REPORT COA2019-054

**APPLICATION FOR MINOR VARIANCE
160 LINDSAY STREET, FENELON FALLS**

**AMENDMENTS TO MINOR VARIANCE APPLICATION COA2019-050
160 LINDSAY STREET/563 CKL RD 121, FENELON TOWNSHIP**

RE: Minor Variance Application: D20-2019-034
160 Lindsay St - Fenelon Falls, City of Kawartha Lakes

SHEET NO. SITE PLAN	SHEET NO. A1.0
-------------------------------	--------------------------

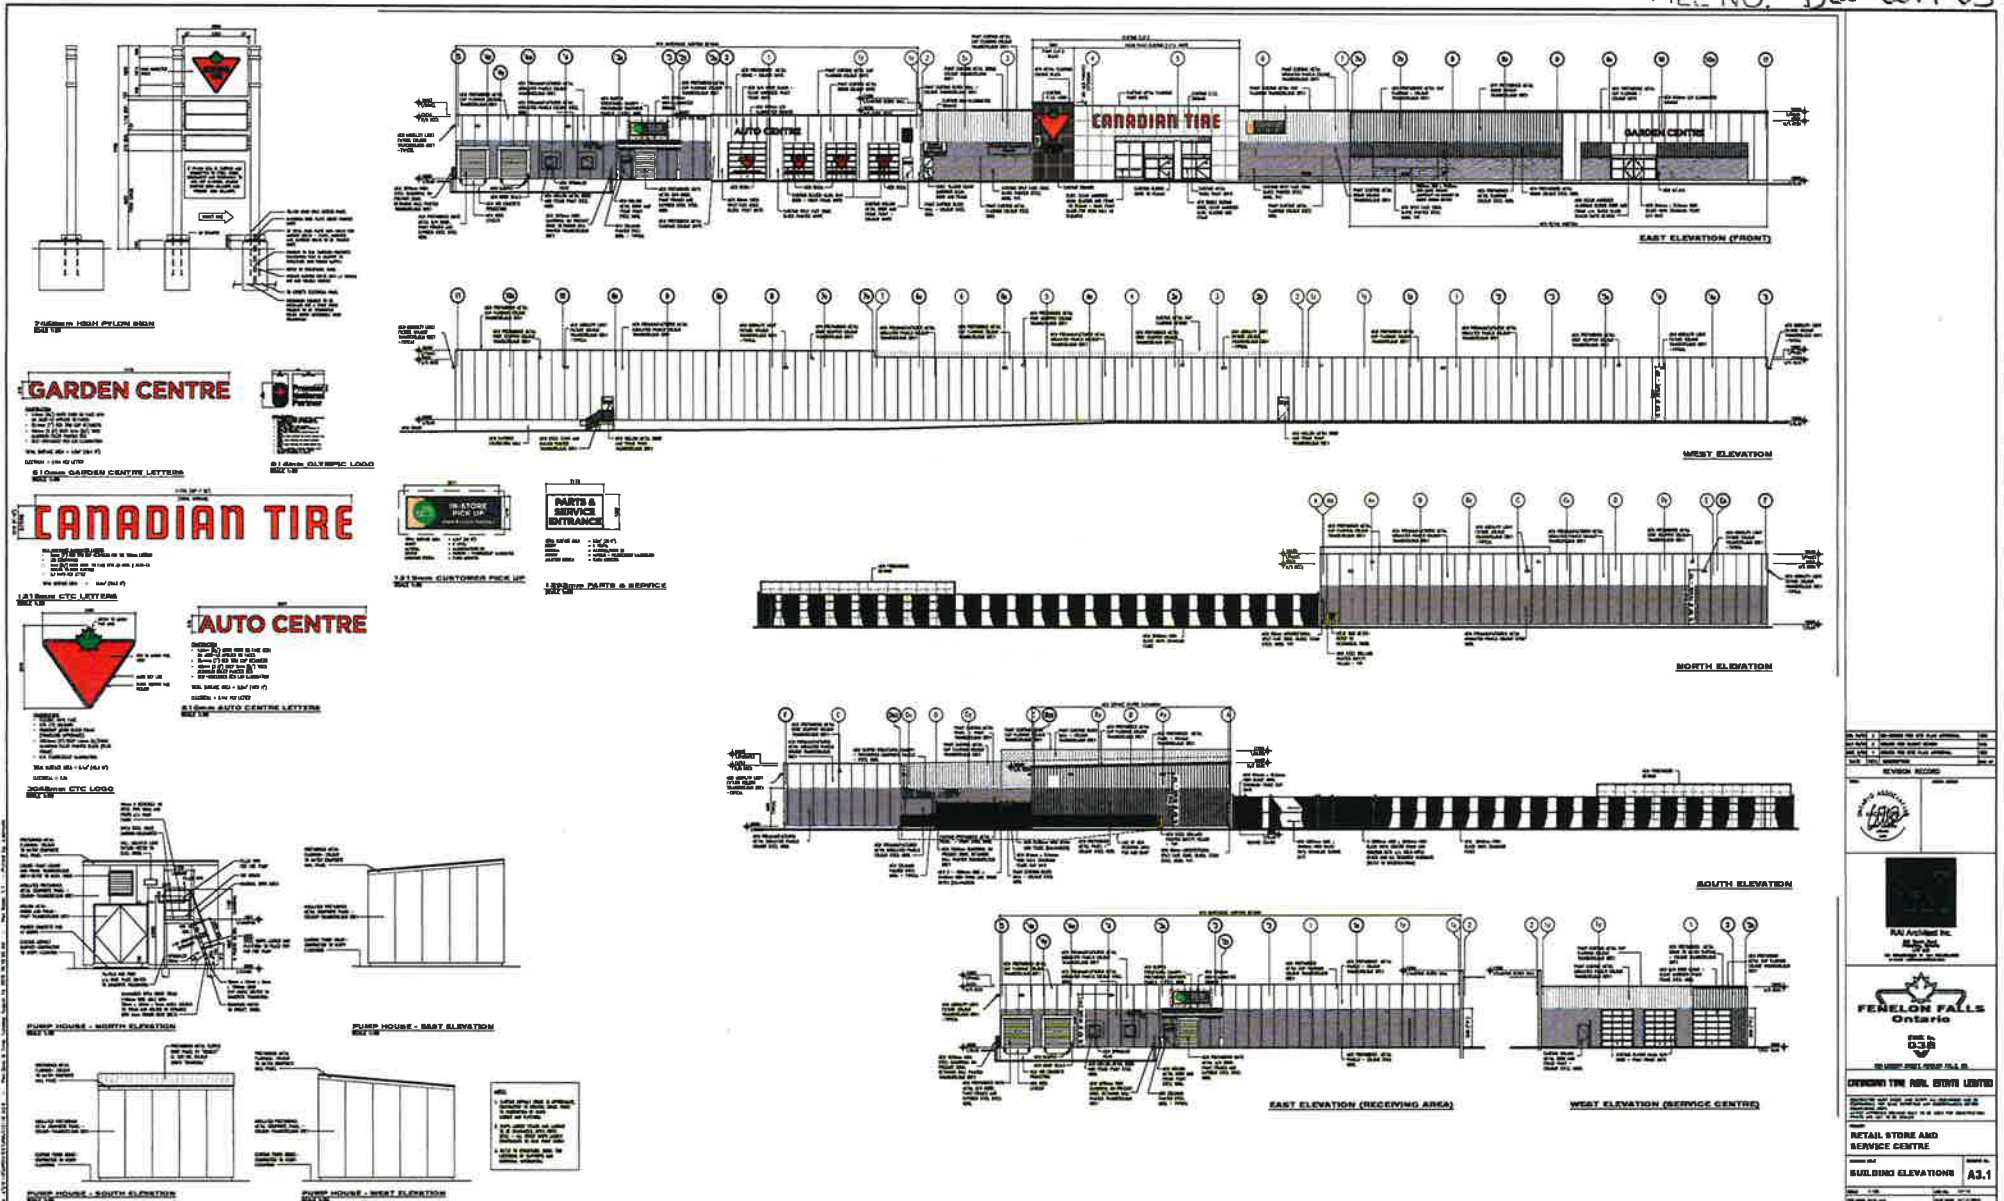
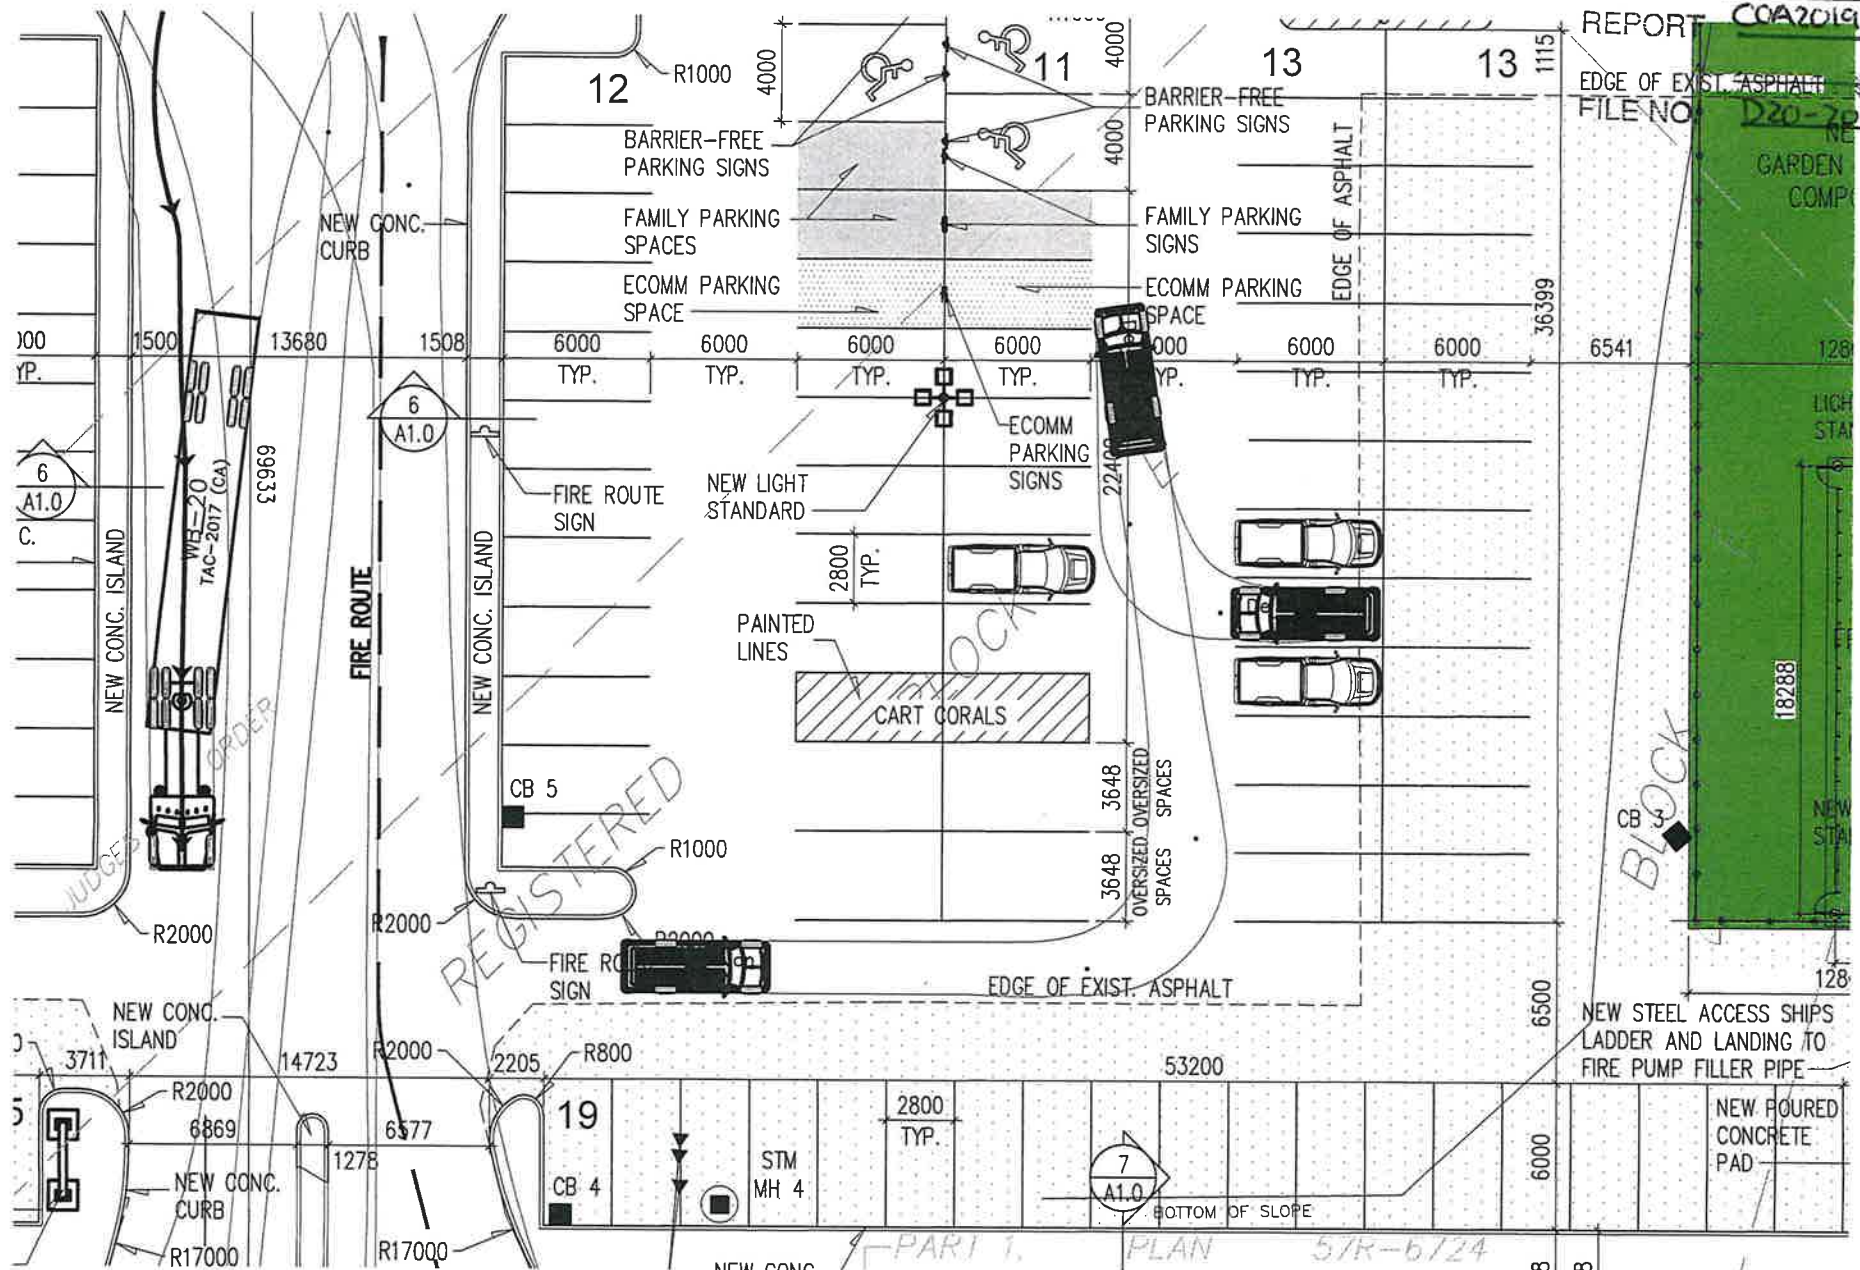
Confirm that the fire route does not need to extend to the pump house (FDC and Siamese provided).
Permits will be required for the sea containers detailing anchorage, founding and exiting.

**CTC FENELON FALLS
STORE No.0038
Parking Illustration
Ford F150**

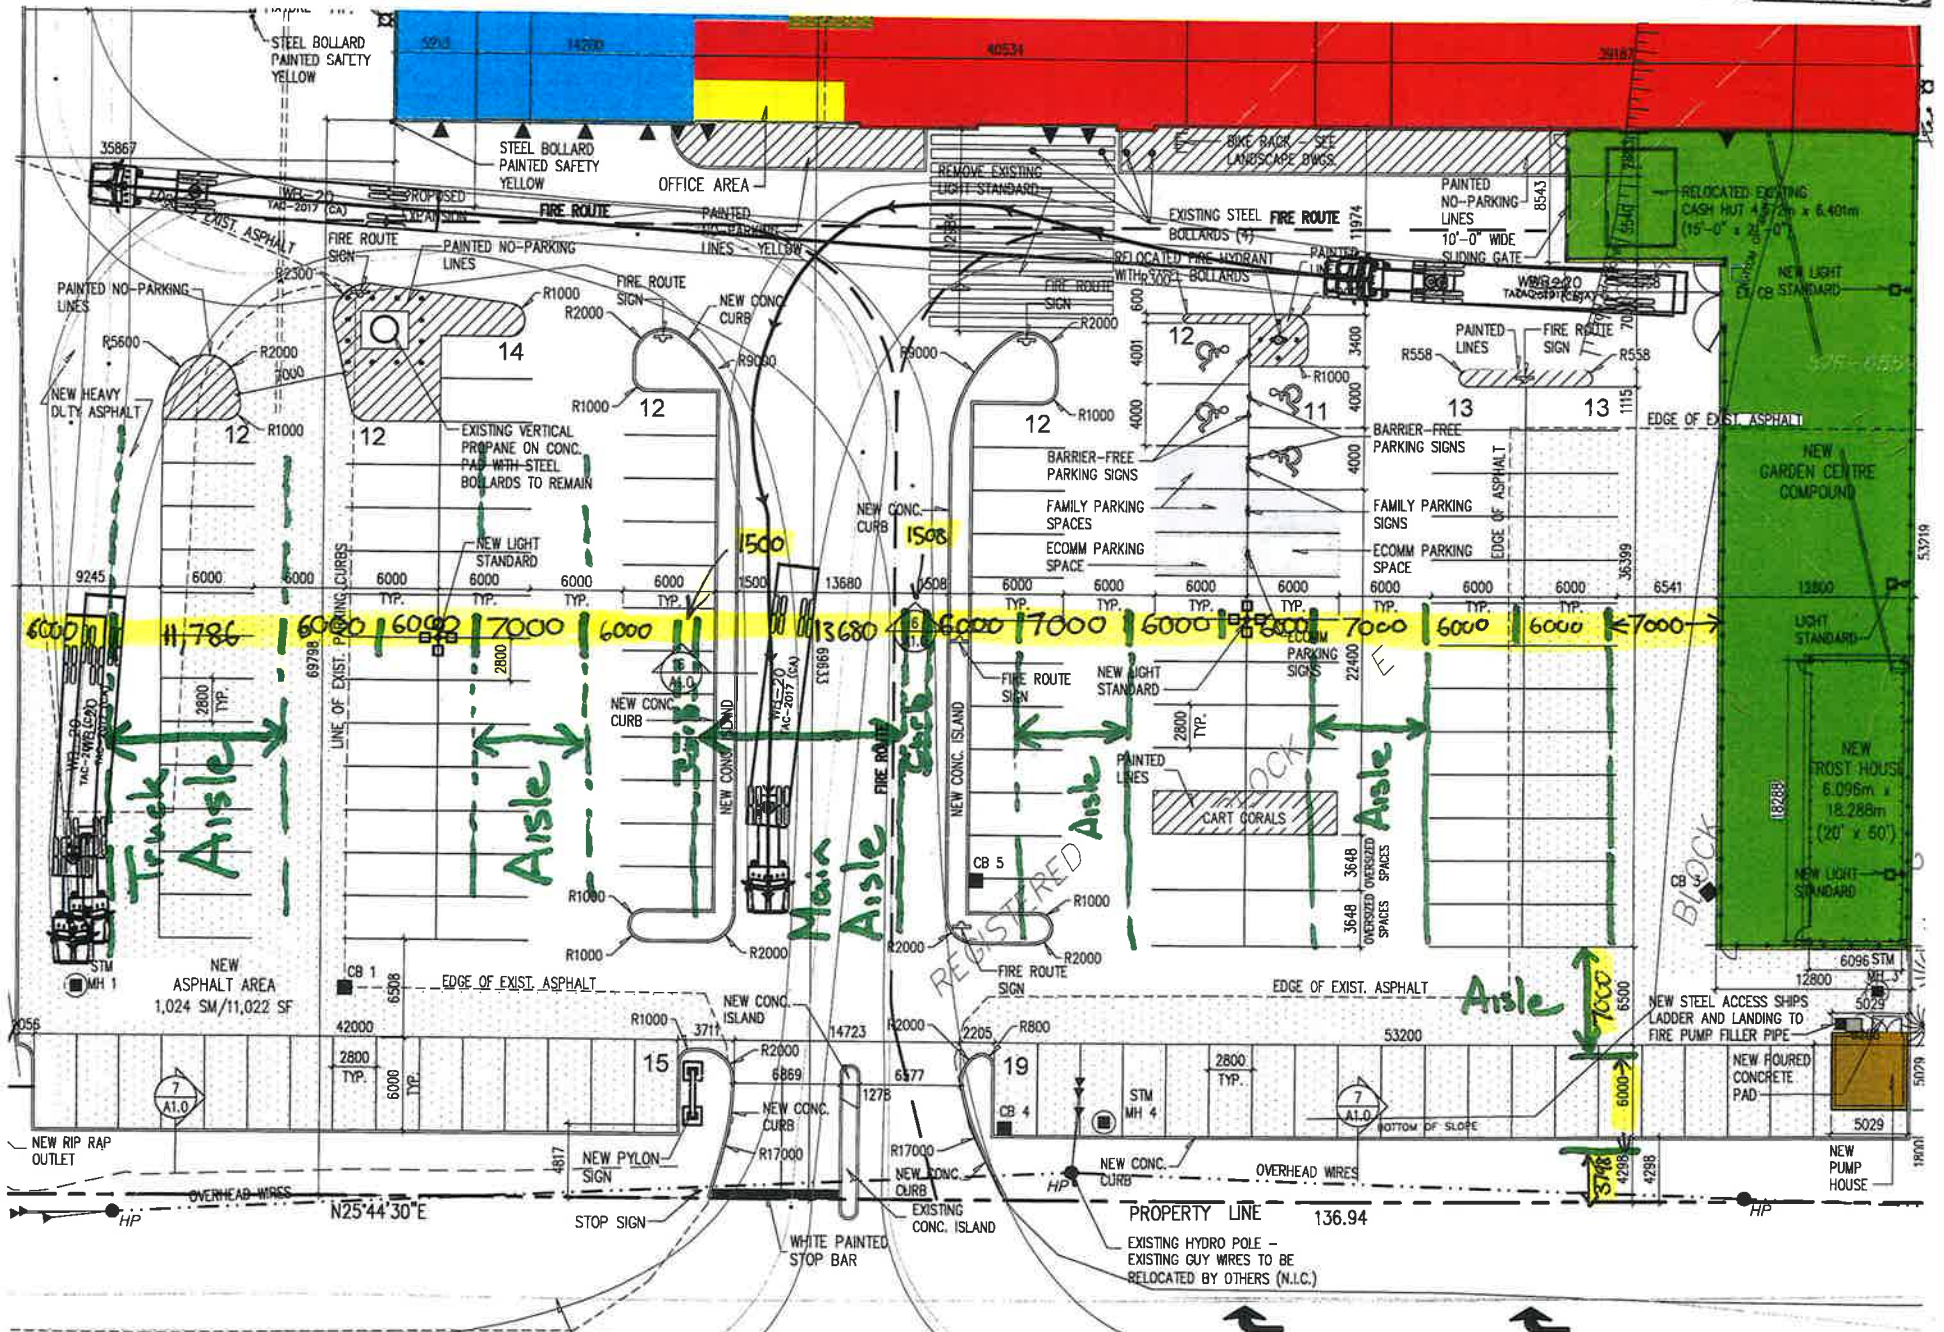
Variance 1: Minimum Aisle Width

As per section 3.14.2.11 of Zoning By-law 12-95, the minimum required aisle width of a parking aisle, when the angle of the parking spaces to the aisle are equal to or greater than 70 degrees but less than or equal to 90 degrees, is 7.0 metres. In this particular case, a minimum width of 6.0 metres is proposed.

The parking aisles will continue to be fully functional and continue to allow for adequate maneuvering space in the parking lot. By reducing the aisle width, from 7.0m to 6.0m, the site is able to accommodate parking stalls with a length of 6.0m, in accordance with the Zoning By-law. It should be noted that Canadian Tire strives for an 18.0m combined width for double loaded drive aisles across all sites in the province, which is being achieved at

Based on correspondence with staff, the reduction of the aisle width to 6.0 metres is recommended for the lands as an alternative to reducing the length of parking stalls. By allowing for 6.0m parking stalls, the opportunity for overhang of larger vehicles into the drive aisle is reduced, which was determined to be more desirable. The reduced drive aisle width maintains adequate maneuvering space throughout the parking lot. As previously noted, Canadian Tire strives for an 18.0m combined width for a double loaded drive aisle across all sites in the province, which will result from the proposed variance. As such, variance will allow for the subject lands to stay consistent with other Canadian Tire properties and will not impact traffic flow throughout the property. Therefore, it is our opinion that the variance is both desirable and appropriate.
